Development Control Committee A 25 February 2015

S TE ADDRESS: 28 Radnor Road Bishopston Bristol BS7 8QY

APPL CAT ON NO: 14/05616/F Full Planning

Sub-division of an existing dwelling to create a total of 4 new units (3 no. one bedroom flats and 1 no. two bedroom duplex) and erection of a side extension.

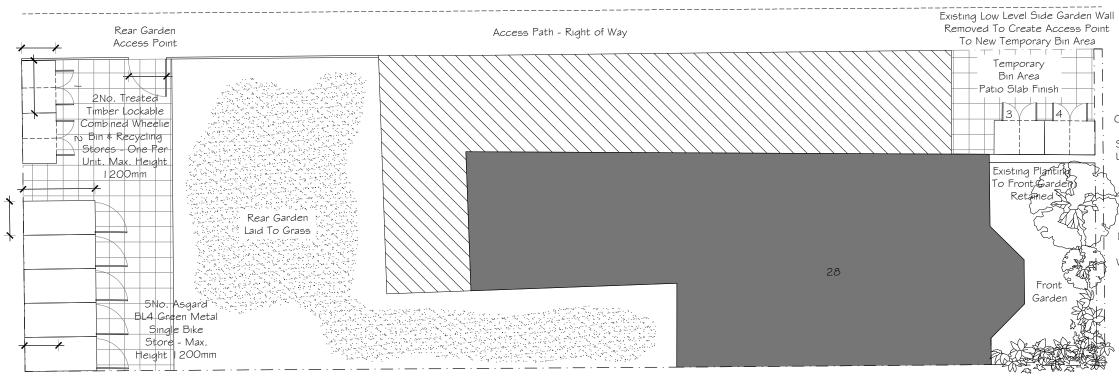
The extension as now proposed is set back from the host building on the front elevation and at roof level, the roof pitch matches existing, it uses materials to match on the front elevation and features have been added to the side elevation to break this up visually.

Concerns over the impact on the approved house on the land adjoining stemmed mainly from the windows on the side elevation and privacy issues, these have now been reduced to two and they are sited on the ground floor only and partly screened with louvers with the result that the privacy of the approved house will not be unduly compromised. The elongated form of the two-storey side extension could result in some loss of light to the rear of the consented dwelling however it is not considered that this would be to an extent to justify objection.

Facing neighbours have expressed concern over loss of light arising from the two storey extension. It is recognised that this will have some impact on the outlook of facing properties but the intervening distance will mean that there will be no direct loss of light that could justify objection.
